## General Information

*GI-1 Comparison between the topographical features in License Application (LA) Figures 1-3 and 1-4 gives the impression that the 640-acre plot would extend beyond the county sections represented in Figure 1-4. Consistent with NUREG-1520, Section 1.1.4.3(2), trace out the 640-acre property on LA Figure 1-4, similar to LA Figure 1-3, to clarify how county Sections 26, 27, 34 and 35 overlap with the 640-acre property.*

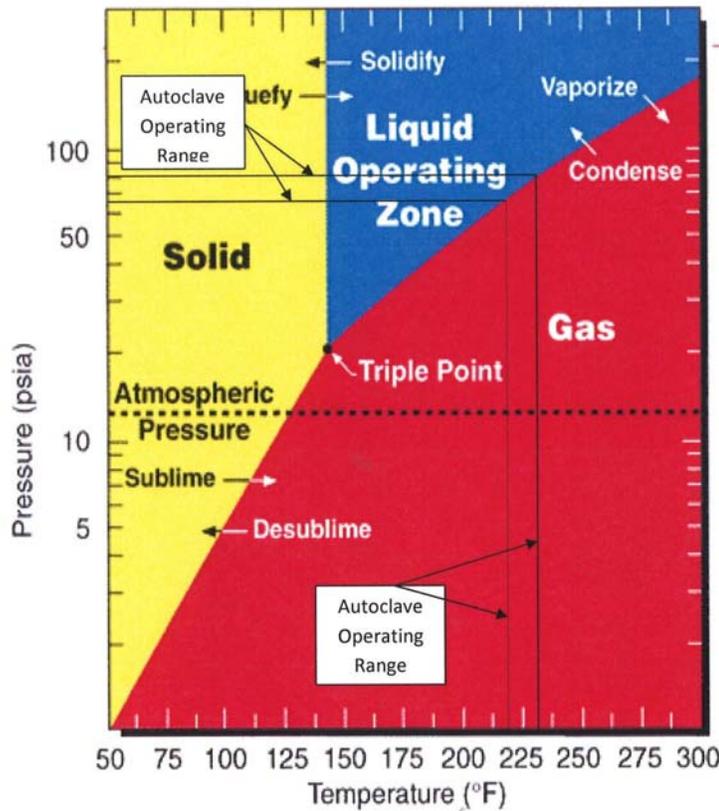
- A. LA Table 1-1 lists the projected average for various chemicals used in the process. Each chemical is represented by a range of values. Clarify if the range of values is the minimum and maximum quantity. If not, describe how these ranges of values are calculated and how they represent an average. Add a description of the physical form (gas, powder, liquid) of licensed material listed in Table 1-1.

We are revising Table 1-1 from a projected average to a table of estimated typical range of inventories for the facility projected (design) production capacity. An additional table column (number three) will be added to provide a description of the physical form of the materials listed in Table 1-1.

**License Documentation Impact:** The original Table 1-1 in Section 1, “General Information”, Revision A of the IIFP License Application is being deleted in total and a new Table 1-1 is being added as shown below. The original paragraphs six (also modified in response to RAI GI-2) and seven along with Table 1-1 will read as follows (black text is original and red text is change or new):

GI-10

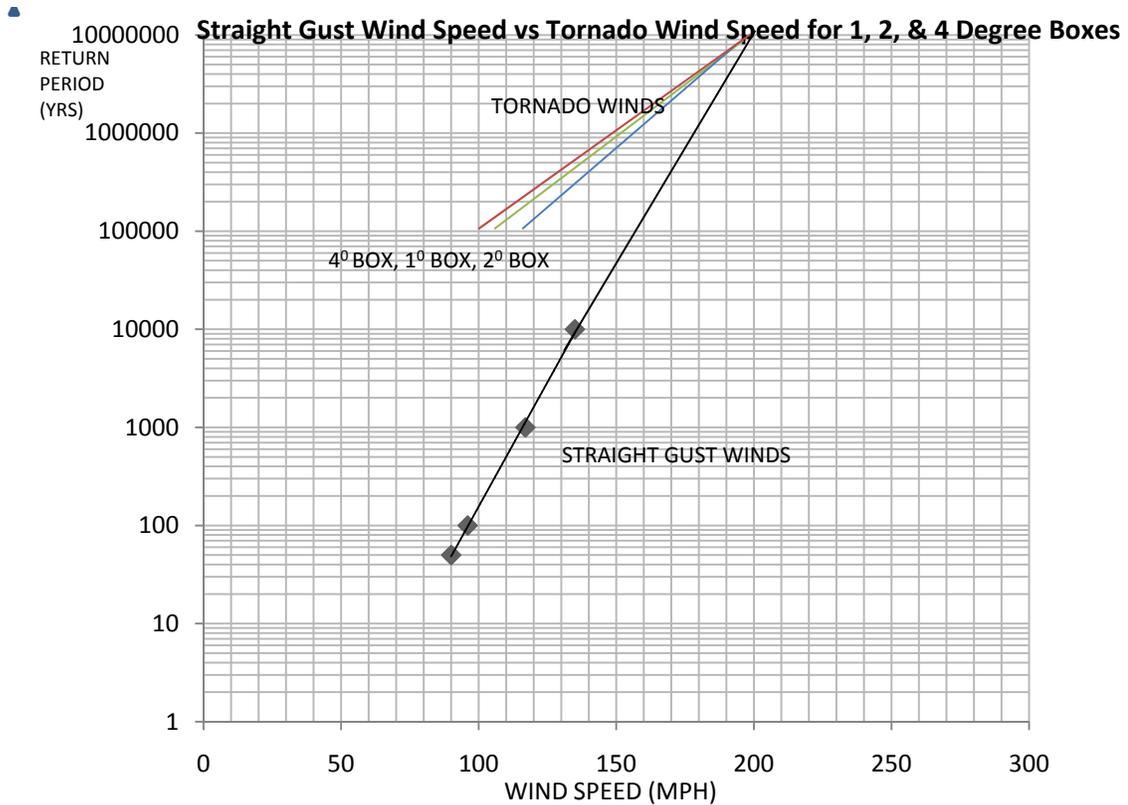
D. For the design basis wind strength in the ISA Summary, provide a return year period and maximum wind speed for both intermediated term (100-500 years) and long term (>1000 years). Specify the basis for both the maximum wind speed and return year period for the information, e.g., a site-specific study, national weather service, etc. In addition, Table 3-22 in the ER has a very limited timeframe (82-97). Justify that this limited timeframe is adequate for the design basis wind. Demonstrate that the wind assessments were from a recognized source and the method used for analyzing high-wind hazard is a commonly used and accepted method.

**RESPONSE:** The determination of design basis wind speed has been reevaluated using a different methodology and under a different set of criteria than those addressed in Question GI-10 D. A discussion of that methodology is provided in this response.
